**BEFORE THE OFFICE OF ENERGY INFRASTRUCTURE SAFETY
OF THE STATE OF CALIFORNIA**

**OPENING COMMENTS OF THE UTILITY REFORM NETWORK
ON PACIFIC GAS AND ELECTRIC COMPANY'S
2026–2028 WILDFIRE MITIGATION PLAN**

May 23, 2025

Table 3. Average Number of Customers Impacted per PSPS Event (2019-2024)³⁵

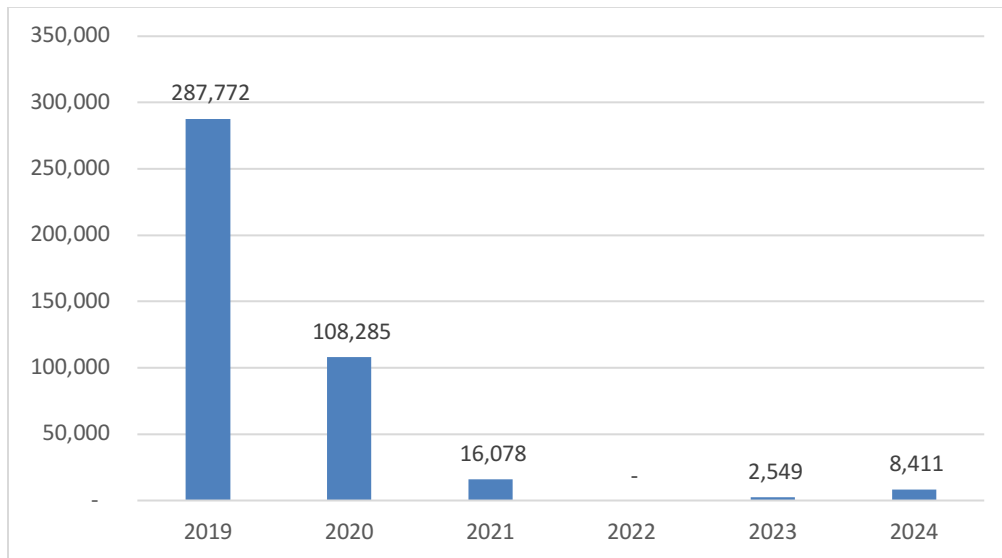
We note that PG&E has already achieved success at reducing the outage risk of PSPS; attitudes toward PSPS may be somewhat skewed by the horrendous reliability impacts of PSPS when PG&E first deployed it (poorly) in 2019. Since then, PG&E has consistently improved its targeting of PSPS events to reduce outages experienced by customers, as discussed in the utility’s WMP.³⁴ The figure below shows the average number of customers de-energized per PSPS event from 2019-2024.

Clearly, PSPS is much more targeted and causes a much shorter average outage than was the case in 2019 through 2021. This progress, particularly if continued even to a less dramatic degree, enables future efforts to mitigate the remaining undesirable impacts of PSPS (such as portable generators) to be more targeted and cost-effective than undergrounding.

Table 4. Customer Minutes of Outage per RFW CMD (2019-2024)³⁶

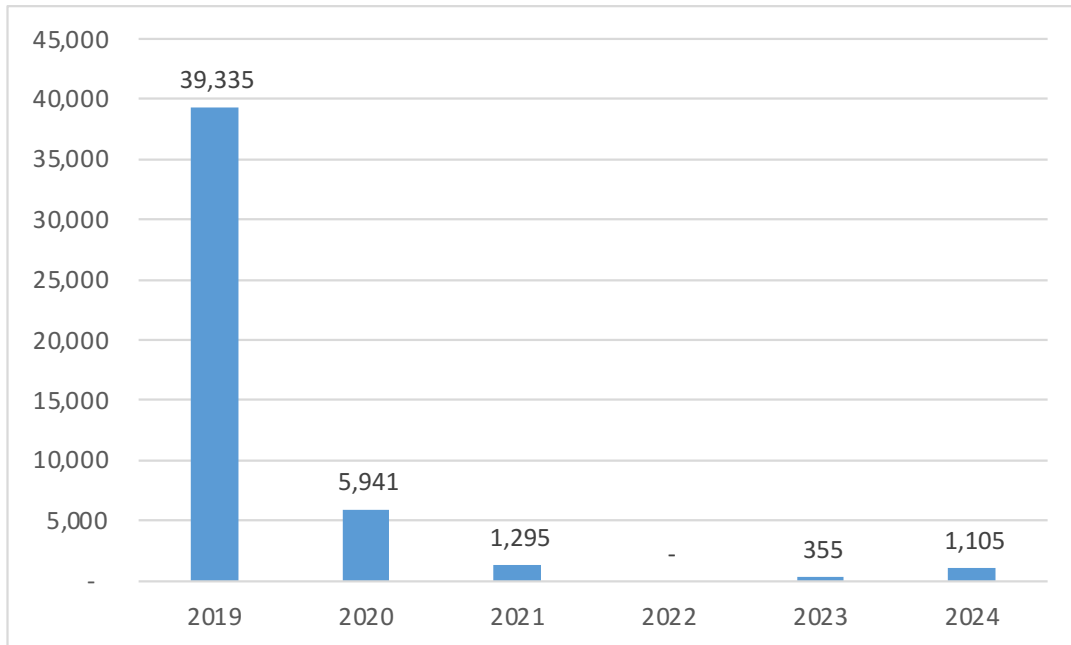
This trend is also apparent in annual customer outage duration statistics. The figure below shows customer outage minutes per red flag warning (“RFW”) circuit mile day (“CMD”), which adjusts outage minutes to reflect relative differences in the weather each year (which drives, or should drive, the number and scale of PSPS events), as measured by the RFW CMD statistic.
